**RESPONSE TO REQUEST FOR ADDITIONAL INFORMATION
IN REGARDS TO REQUEST FOR LICENSE AMENDMENT
INCREASED LICENSED POWER LEVEL
SALEM GENERATING STATION, UNIT NOS. 1 AND 2
FACILITY OPERATING LICENSE DPR-70 AND DPR-75
DOCKET NOS. 50-272 AND 50-311**

**ATTACHMENT 1
SALEM GENERATING STATION
UNIT NOS. 1 AND 2
FACILITY OPERATING LICENSE DPR-70 AND DPR-75
DOCKET NOS. 50-272 AND 50-311
RESPONSE TO REQUEST FOR ADDITIONAL INFORMATION
INCREASED LICENSED POWER LEVEL**

**SALEM GENERATING STATION
UNIT NOS. 1 AND 2
FACILITY OPERATING LICENSE DPR-70 AND DPR-75
DOCKET NOS. 50-272 AND 50-311
CHANGE TO FACILITY OPERATING LICENSES**

Figure 3.4-2 . Salem Unit 1 Reactor Coolant System Heatup Limitations
 Applicable for Heatup Rates up to 60°F/HR for the Service
 Period up to 15 EFPY

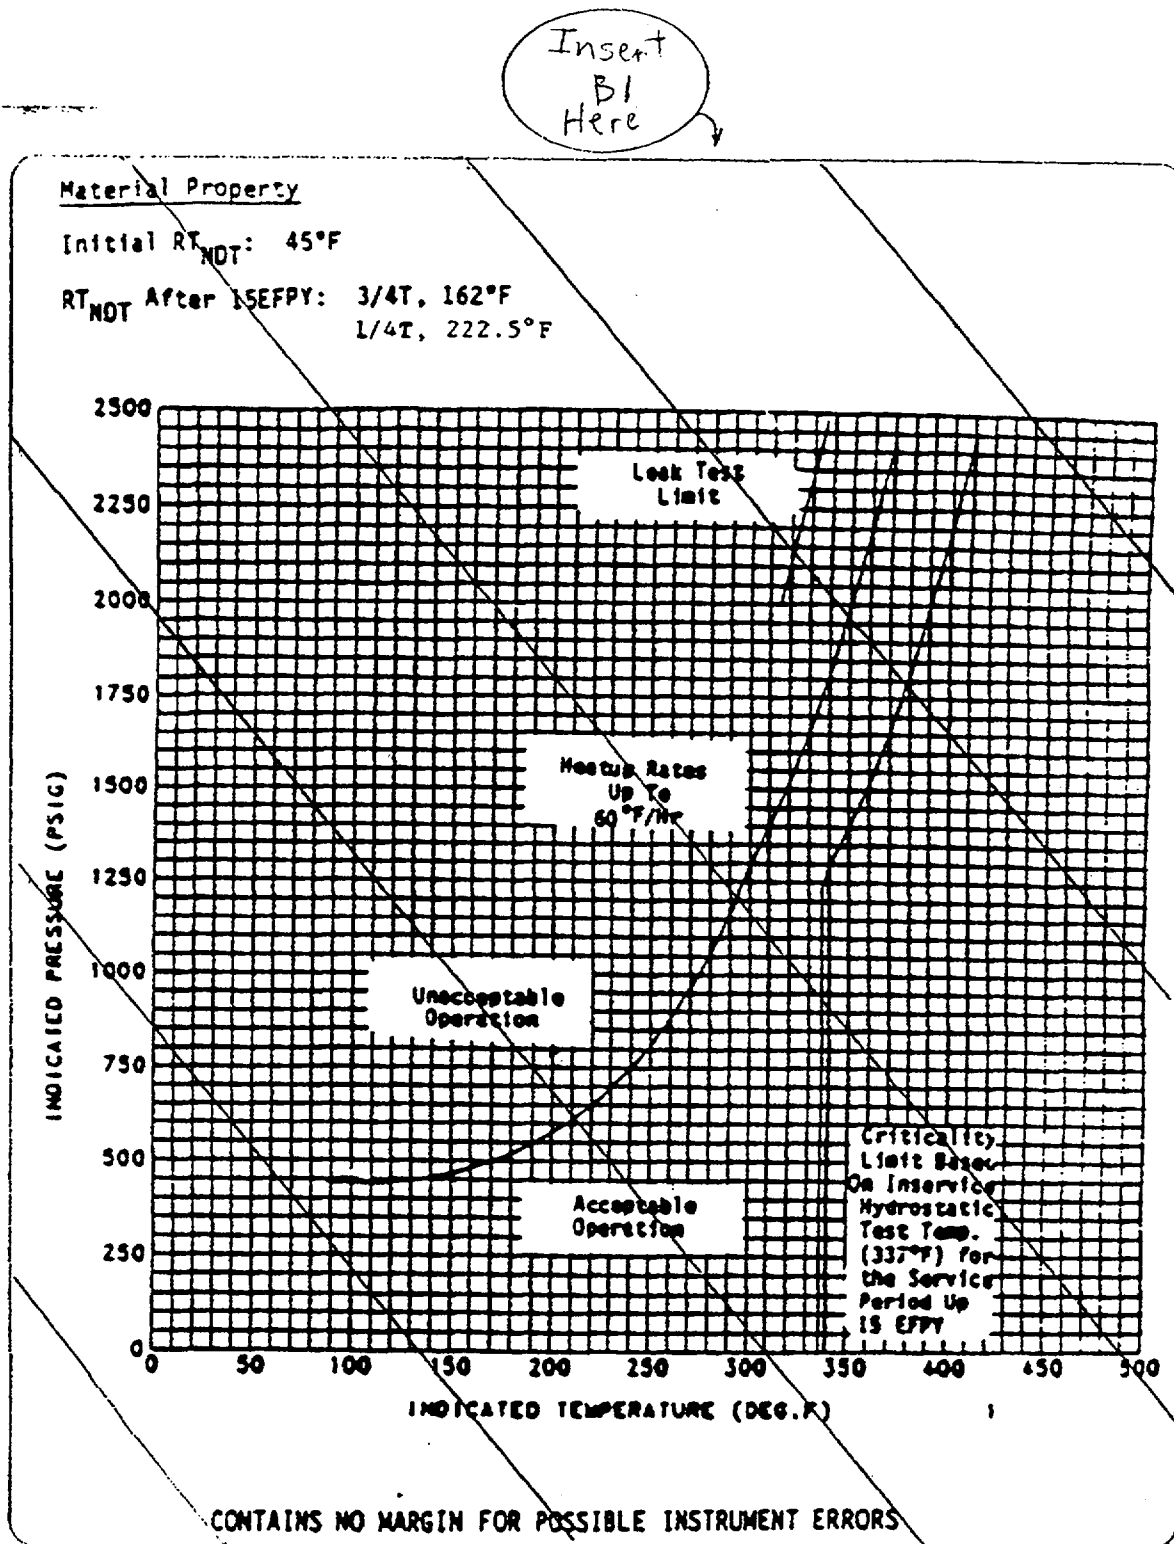
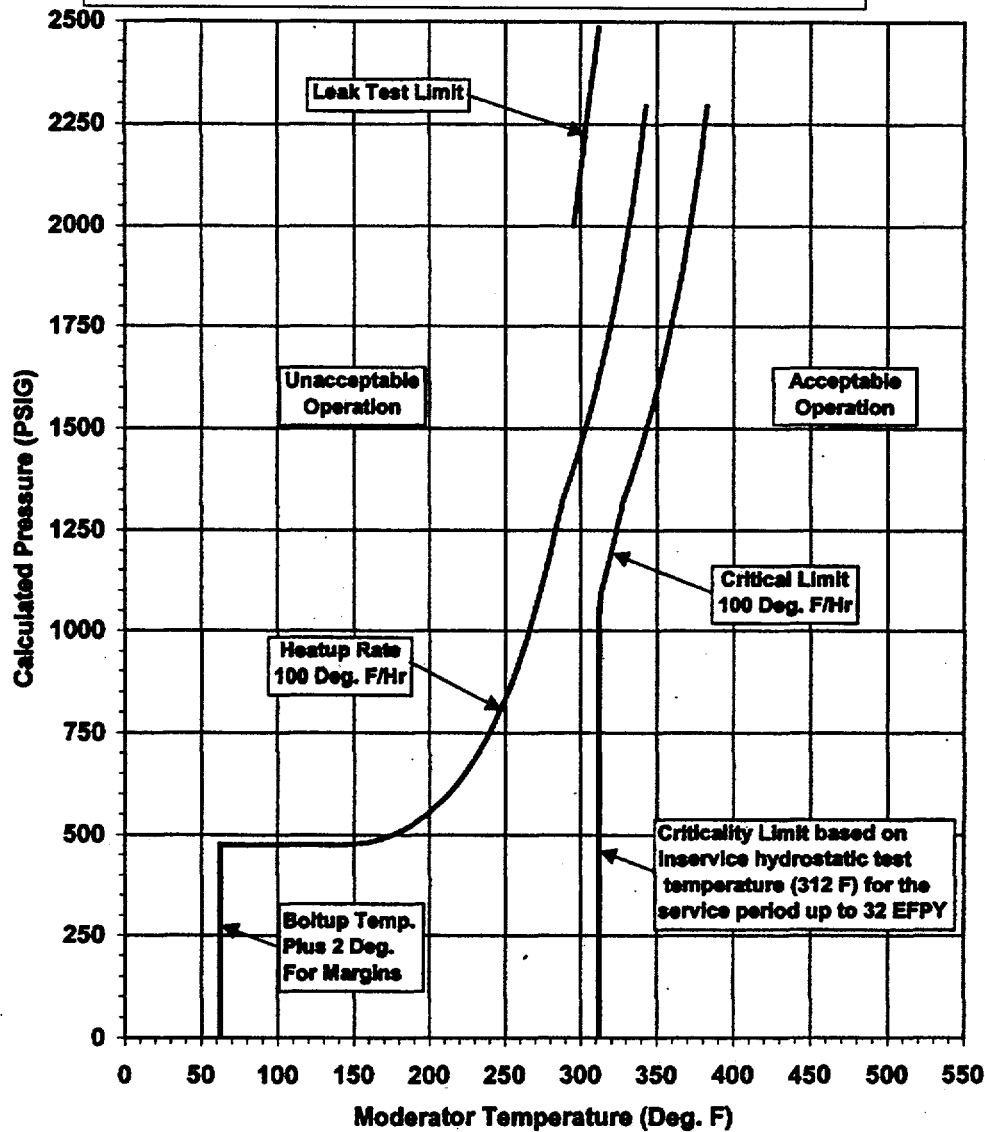
(32)

INSERT B1

@1/4T	@3/4T
Initial RT _{NDT}	-56°F	45°F
RT _{NDT} after 32 EFPY	232°F	171°F

1. Technical Specification Figures 3.4-2 and 3.4-3, Reactor Coolant System Heatup and Cooldown Curves, and their associated Bases are revised to support the increase in core power based on uprated fluence projections. The revised curves are applicable for the service period up to 32 effective full power years (EFPY). The maximum heatup rate for Figure 3.4-2, Reactor Coolant System Heatup Limitations, is being changed from 60°F/hr to 100°F/hr. The revised curves are being adjusted to account for pressure and temperature instrument uncertainties and the curves are being extended to show minimum boltup temperature. The values in Bases Table B 3/4.4-1, Reactor Vessel Toughness Data, for Unit 1 and 2 are being updated to reflect information related to reactor pressure vessel integrity previously provided to the NRC in response to Generic Letter 92-01 and its supplement.

Figure 3.4-3 Salem Unit 1 Reactor Coolant System Cooldown Limitations
 Applicable for Cooldown Rates up to $100^{\circ}F/HR$ for the Service
 Period up to **15** EFPY

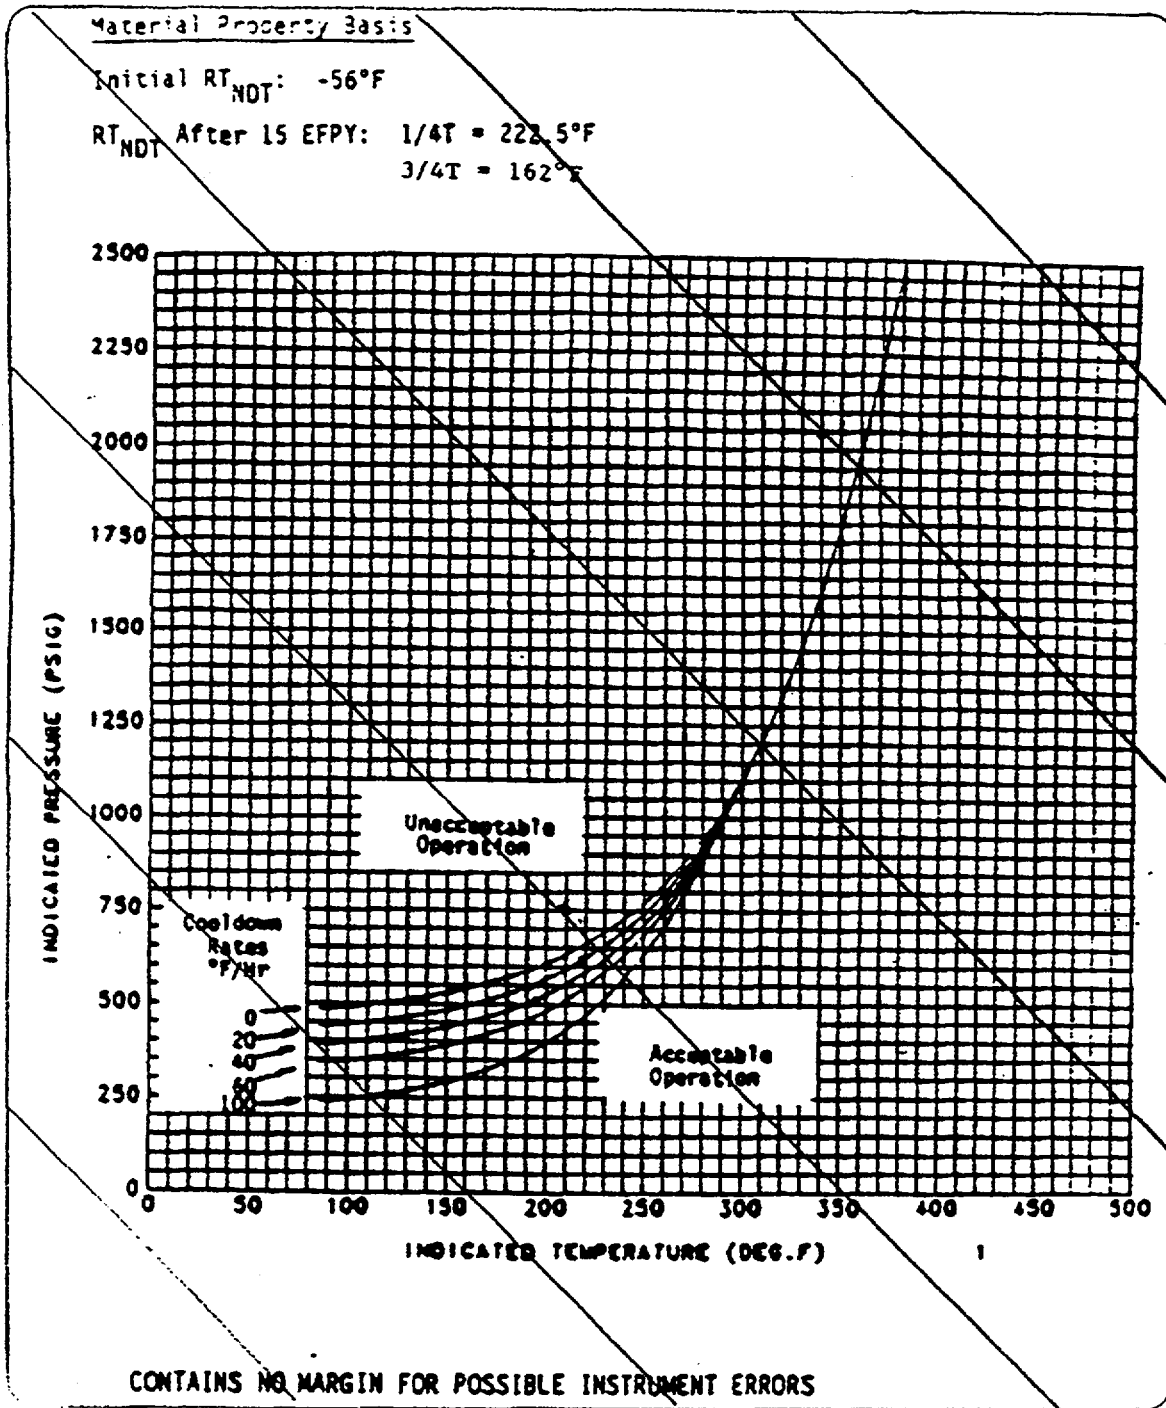
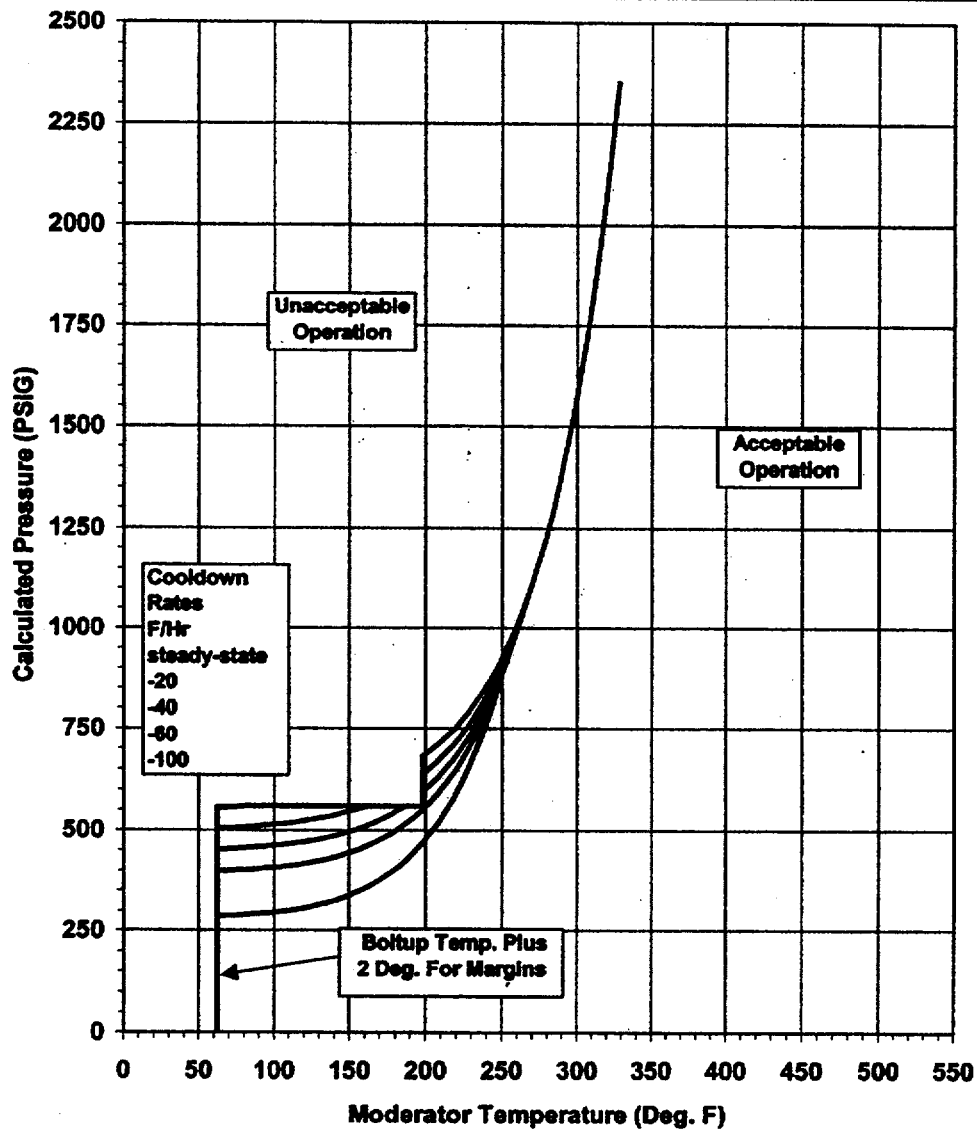
32

INSERT C1

@1/4T	@3/4T
Weld 3-042C		Plate B2402-1
Initial RT _{NDT}	-56°F	45°F
RT _{NDT} after 32 EFPY	232°F	171°F

Figure 3.4-2

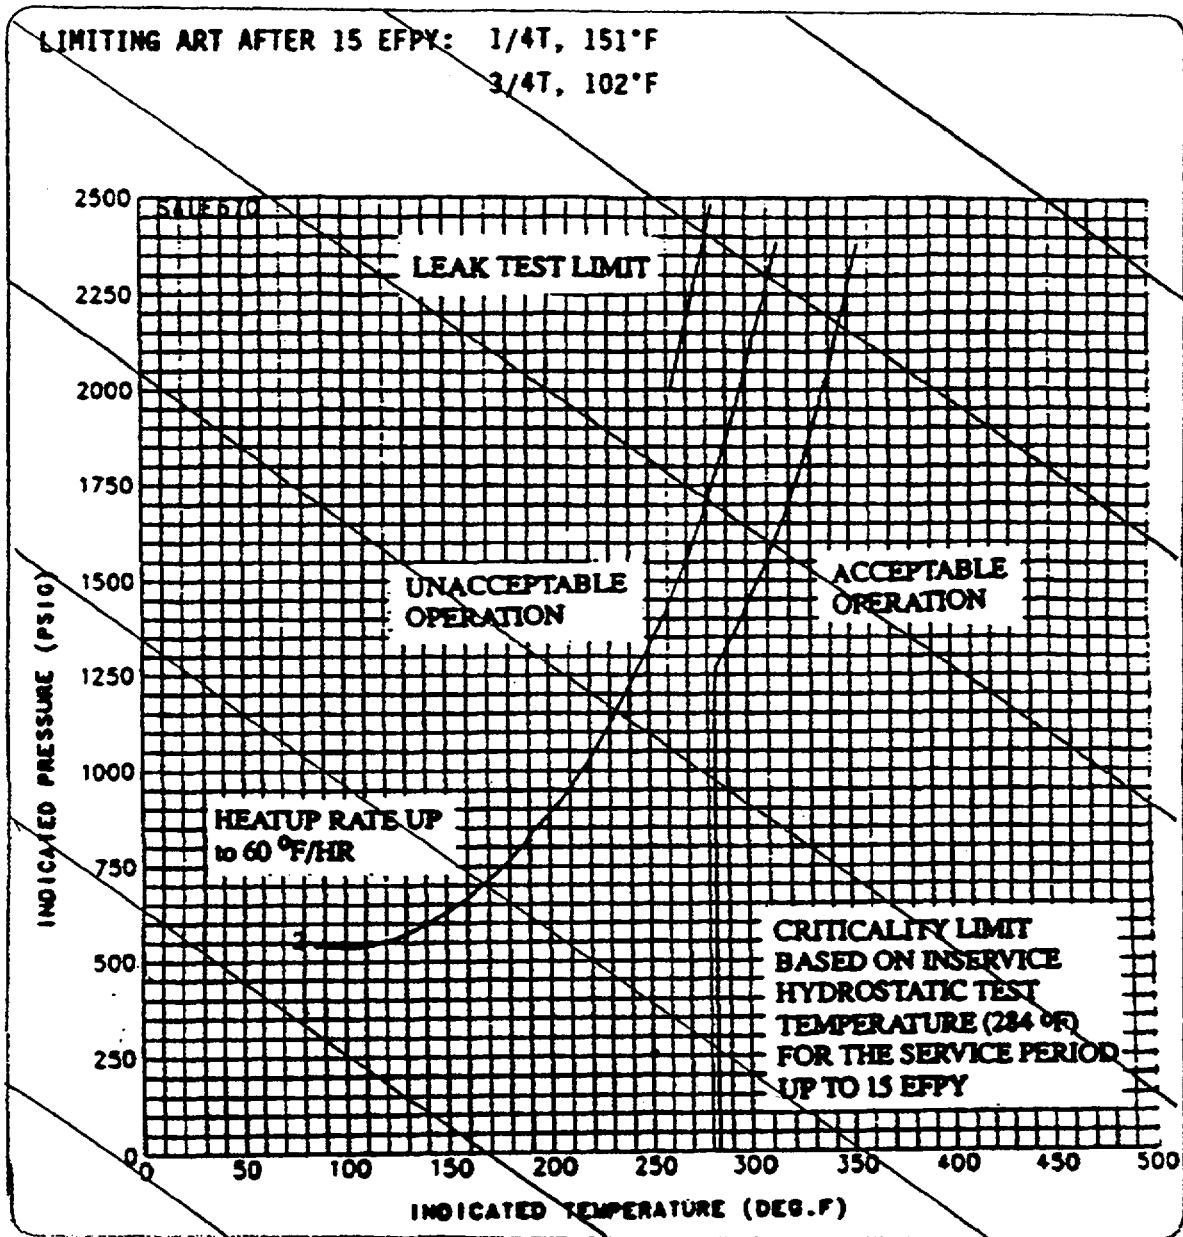
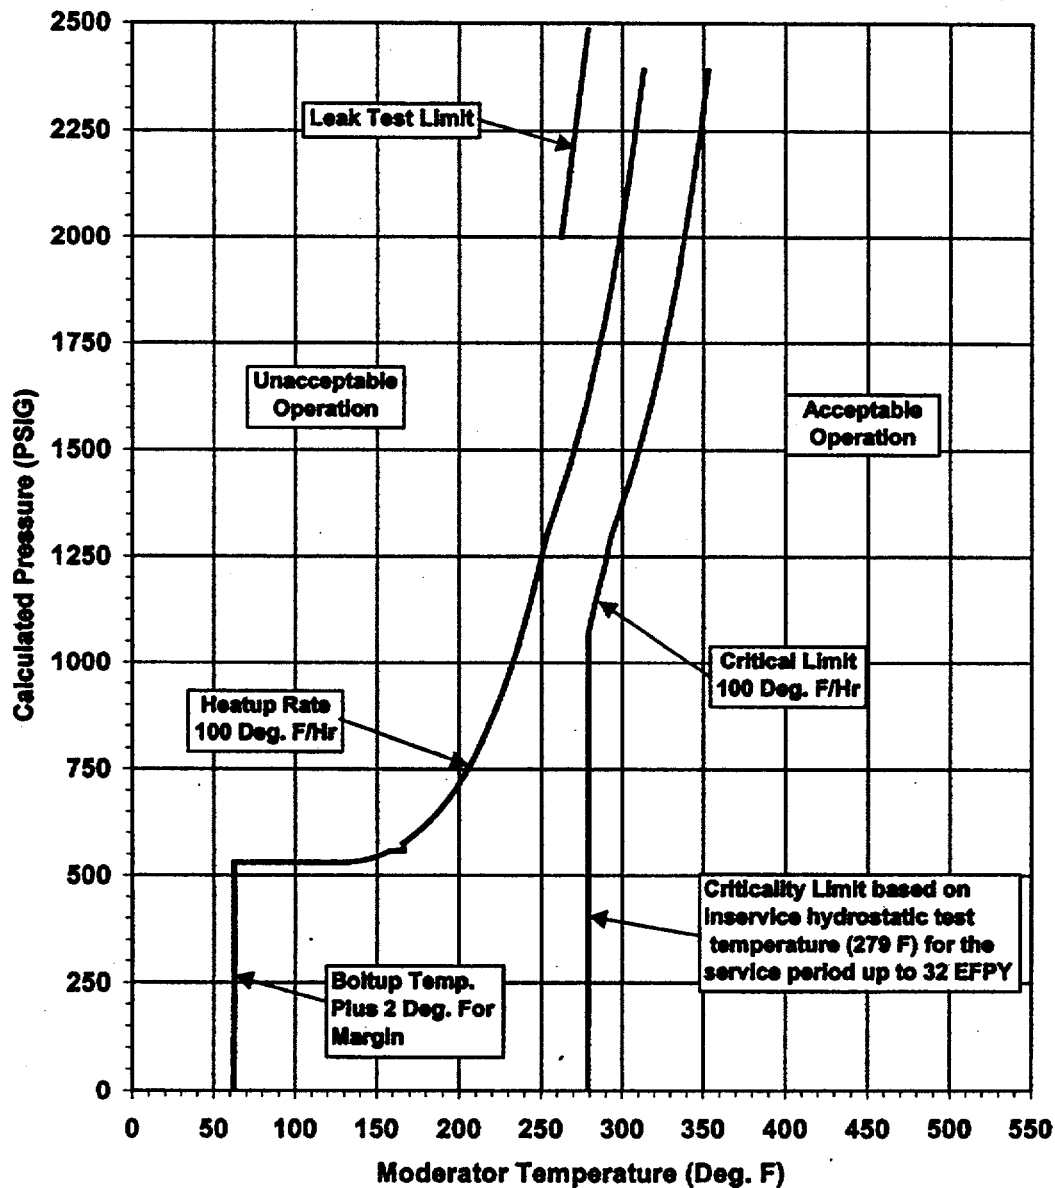
RT_{NDT} after 32 EFPY: 1/4T 199°F
 3/4T 140°F

Insert
C2
Here
